# STAFF RECOMMENDATION

NCPC File No. 6669

**UNITED STATES INSTITUTE OF PEACE**  
NEW HEADQUARTERS AND PUBLIC EDUCATION CENTER  
23<sup>rd</sup> Street and Constitution Avenue, NW  
Washington, D.C.

May 25, 2006

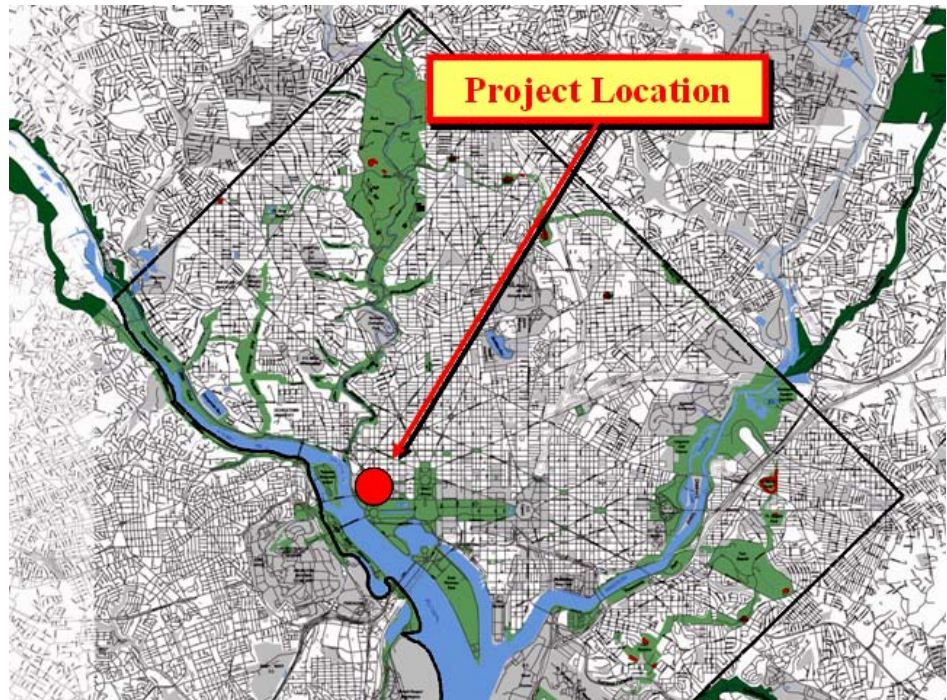
- **Comments favorably** on the concept site and building plans for the U.S. Institute of Peace Headquarters and Public Education Center, as shown on NCPC Map File No. 1.33 (38.00)-42034.
- **Requests**, in the U.S. Institute of Peace subsequent preliminary site and building plan submission, that the following elements of the project design be examined in the project development to address the following:
  - The establishment of project site work limits and the extent and nature of the western garden site development and full project grading plan. Currently, the site grading and relationship to the building ancillary entrances appear inconsistent

and severely constrained at the west side of the structure as depicted on the submitted drawings.
